# Access Compliance Report

## Public Rights-of-Way

### (Curb Ramps)

Intersection ID: 21497	Main Street: GREENWAY_VIEW_CT	Cross Street: WITHERS_MILL_DR	Location: W
ADA ID: 7CCC2D28FDE6	Ramp Type: BlendTrans2	Initial Pass/Fail: Fail	Overall Compliance: No
		Severity Score: 35

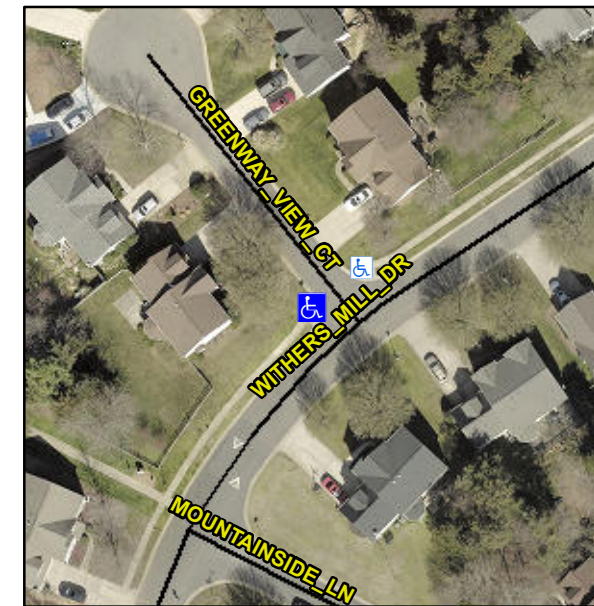
**R304.5.1**

Compliance	Description	Data	Compliance	Description	Data
N/A	Ramp Length (in)	102.0	Yes	BlendTrans Slope (%)	4.2
No	Ramp Width (in)	24.0	Yes	BlendTrans XSlope (%)	1.2
N/A	Flare Type LT	N/A	N/A	Flare Type RT	N/A
N/A	Flare Slope LT (%)	N/A	N/A	Flare Slope RT (%)	N/A
N/A	Flare Traversable LT?	N/A	N/A	Flare Traversable RT?	N/A
N/A	Landing Length (in)	N/A	N/A	DWS Provided?	N/A
N/A	Landing Width (in)	N/A	N/A	DWS Contrast?	N/A
N/A	Landing Slope (%)	N/A	N/A	DWS Length (in)	N/A
N/A	Landing X Slope (%)	N/A	N/A	DWS Full Width?	N/A
N/A	Landing Curb? (Y/N)	N/A	N/A	DWS Offset (in)	N/A
N/A	Shared Landing?	N/A			
N/A	Gutter Ponding?	N/A	N/A	Gutter Slope (%)	N/A
N/A	Gutter Lip Ht (in)	N/A	N/A	Gutter X Slope (%)	N/A
N/A	Painted X Walk1?	No	N/A	Painted X Walk2?	No
	X Walk 1 Direction	To SE		X Walk 2 Direction	To NE
	X Walk 1 Width (in)	N/A		X Walk 2 Width (in)	N/A
	X Walk 1 Slope (%)	5.0		X Walk 2 Slope (%)	0.7
	X Walk 1 X Slope (%)	0.2		X Walk 2 X Slope (%)	0.8

**Remove & Replace Curb Ramp With Two New Directional Ramps or Equivalent.**
